Re: Initial Submission Review – Comment Response Letter –
Stafford Logistics Center Trailer Parking – Master Plan Admt, Site Plan, and Plat Application Number:
DA-2170-06

Case Numbers: **2019-7001-03; 2023-6014-00; 2023-3011-00**

Initial Submission Review

SHEET
C4
4

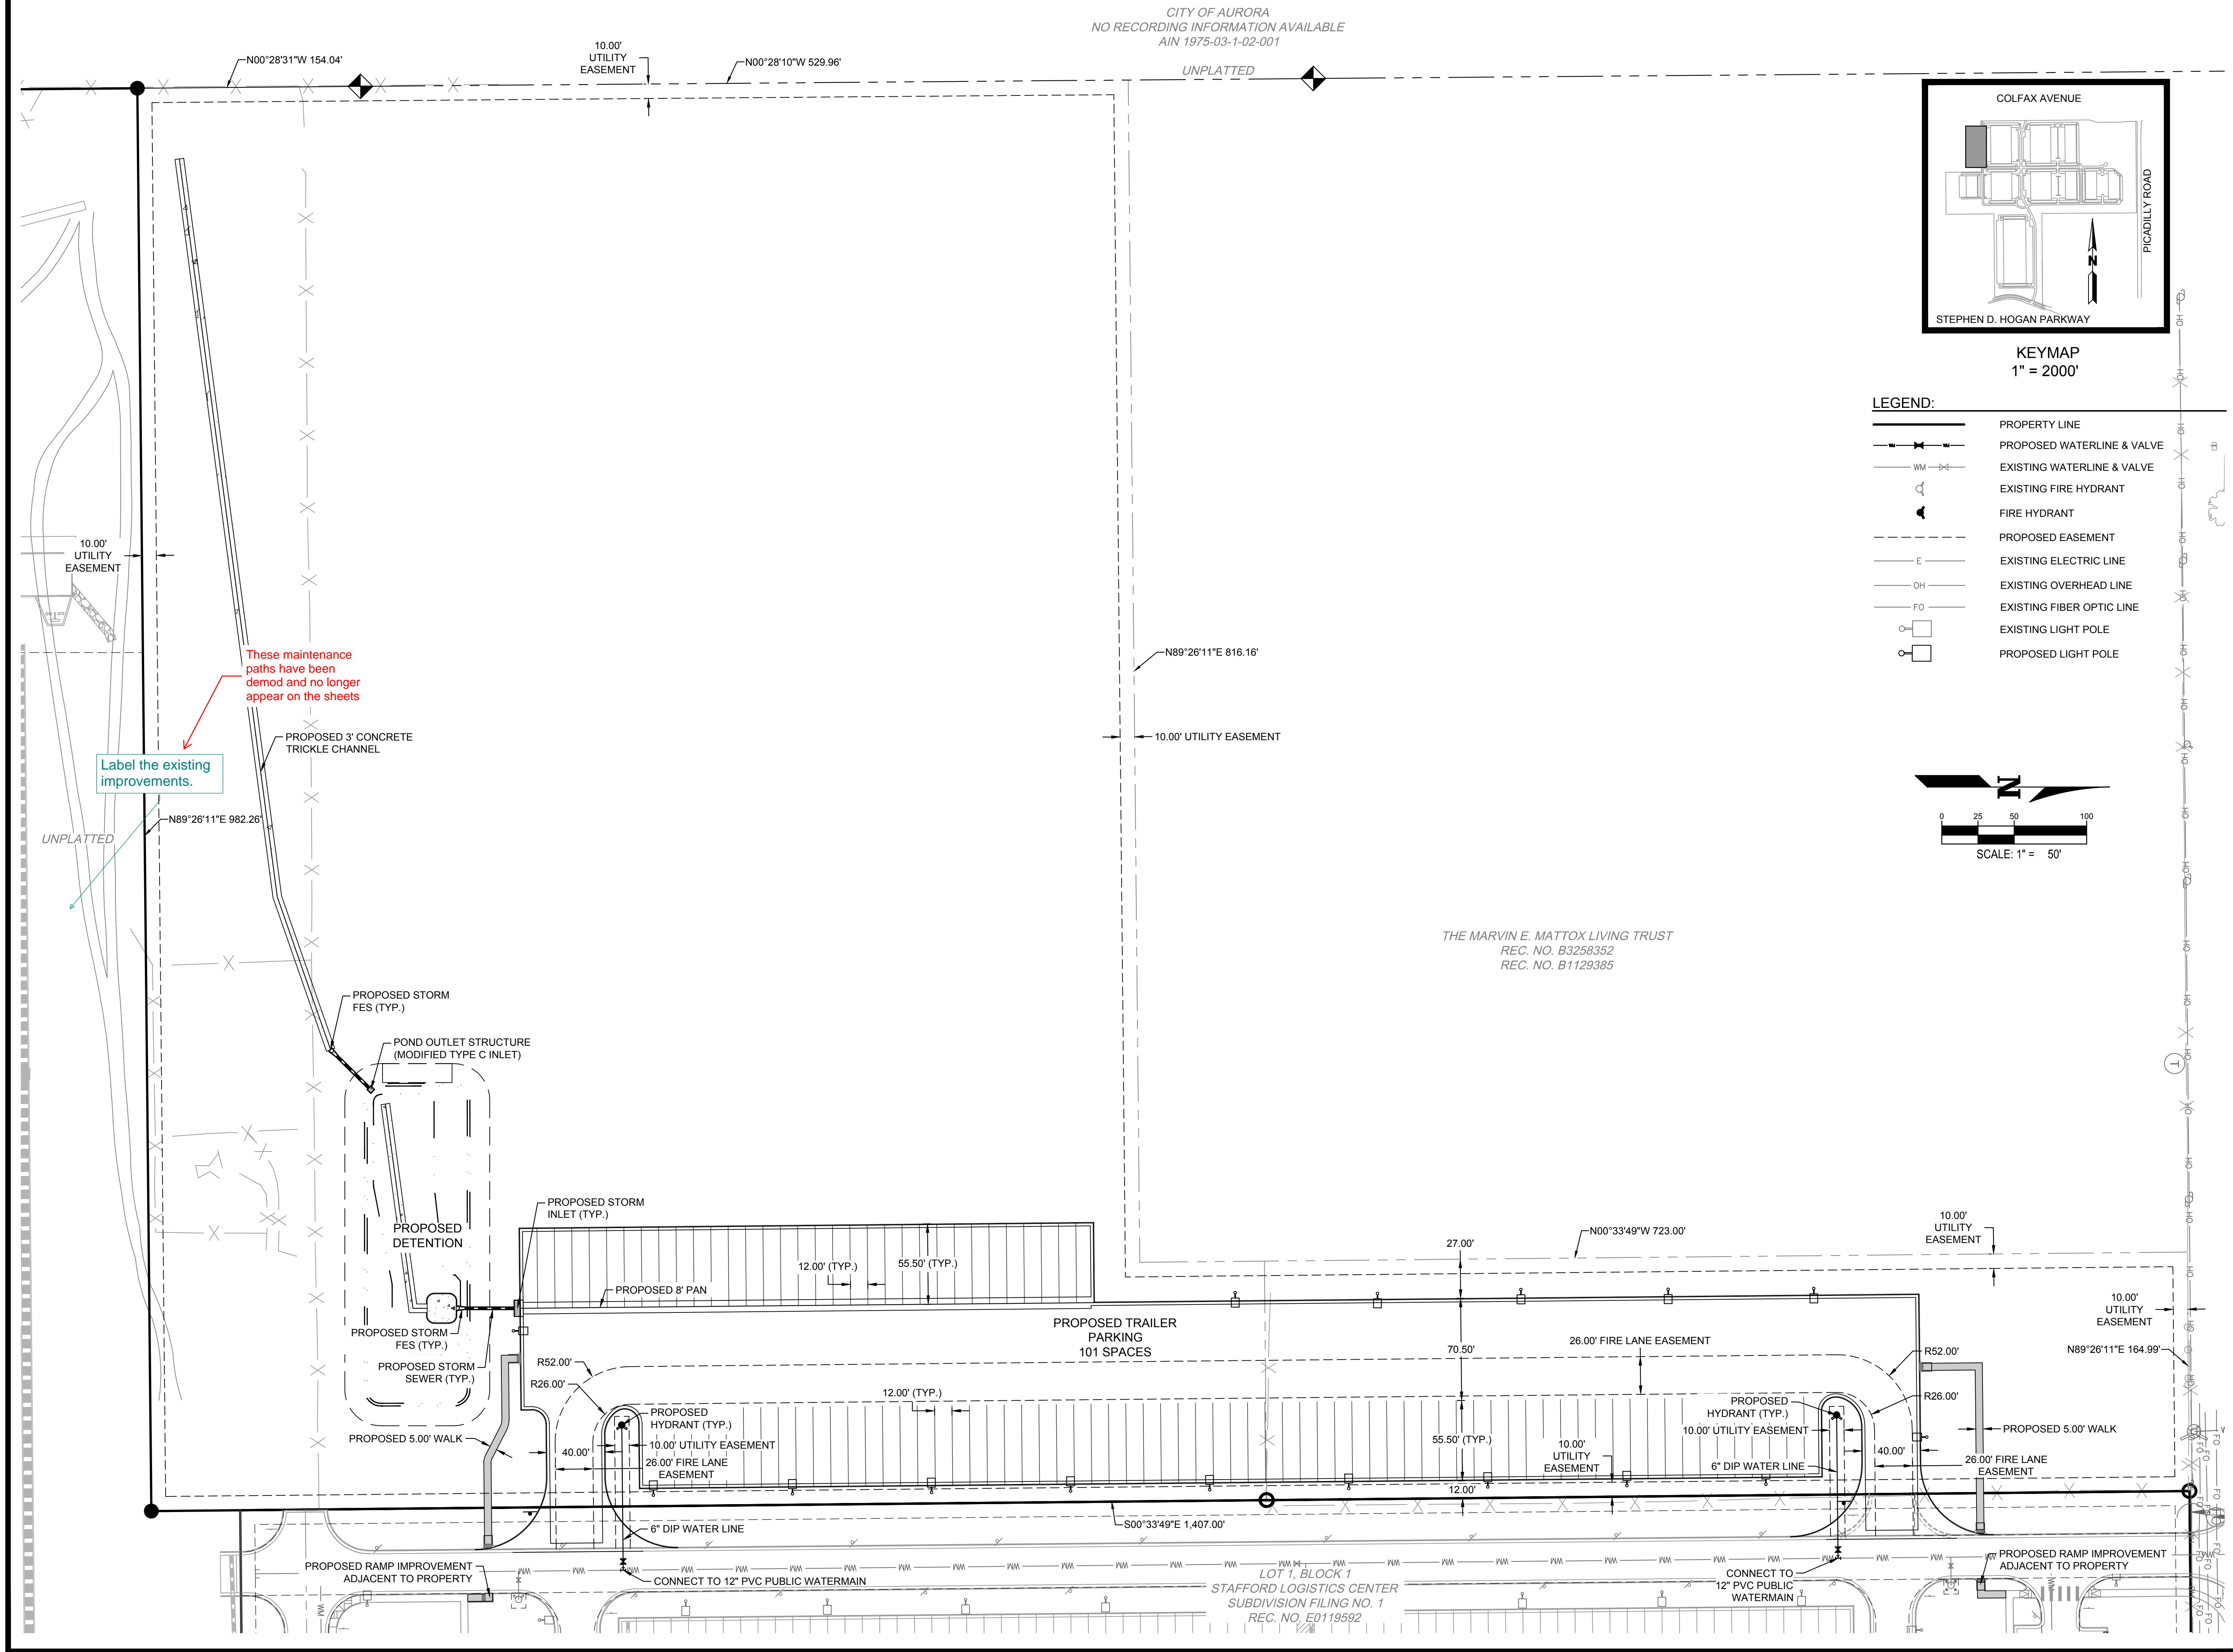
Add a note indicating the storm sewer is public or private and who will maintain it.

Are there proposed contours for this area that should be shown? They appear to be shown on other sheets of this plan set.

A drainage easement is required for all detention/water quality ponds. Show/label the drainage easement.

Show/label the 100-year WSEL in the ponds.

3.4.10 Show the required maintenance access into the bottom of the pond and to the top of the outlet structure.

Note added to grading
— and utility sheets per
comment

Concrete trickle channel has been labeled and slope provided per comment.

Drainage easement is
– shown and called out
per comment.

WSEL for 100, EURV, and
- WQCV storm have been
labeled per comment.

Maintenance access
— been shown and called
out per comment.

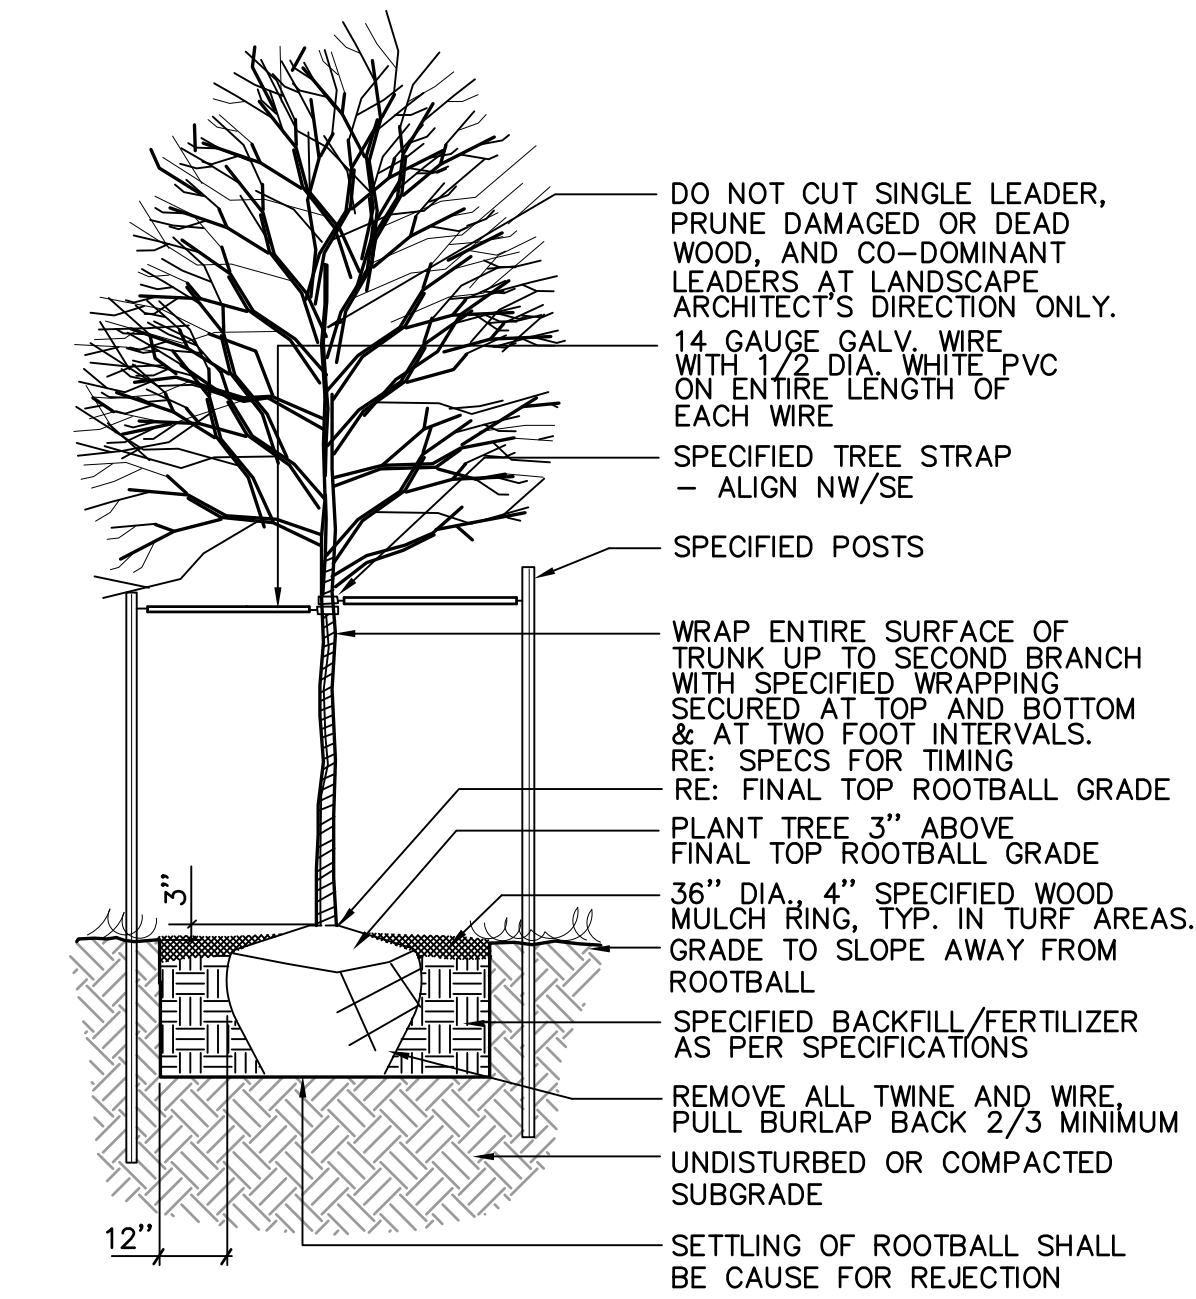
add sight triangles per COA TE-13 at site accesses. Verify mature plant heights within sight triangles meet COA 4.04.2.10 requirements

Add an asterisk and a note to the bottom of the table. That due to the presence of existing utilities within the curbside landscape, the required street trees were located behind the back of walk.

Not required as this area is intended to be included in the over all master planned development.

Is this an existing or proposed fence? If existing, is it being removed and if it is, please remove from the plan. If a new fence is proposed, include the line work symbology in the legend and include a detail of the fence.

Dimension and label the non-street buffer. The buffer starts at 18' and can be reduced to 12'. Refer to the UDO Table 4.7-2. This does not appear to be meeting the minimum requirements. The plant material requirements are one tree and five shrubs per 40 lf and 30% shall be evergreen.

This fire lane easement does not appear to match the easement shown on Sheet C2, C3, and C4 of this set of drawings for Sheet 5 and 6. Please correct the drawings to match. If this is the actual proposed fire lane, No Parking Fire Lane signs shall be posted along this property line.

Show the adjacent property line and provide the dimension.

Remove the words Building 16

Not being met. See comment this plan sheet.

See comment on the landscape plan concerning the north and south buffers

Update to remove the reference to the previous landscape code.

Upon completion of the construction of the expanded parking lot.
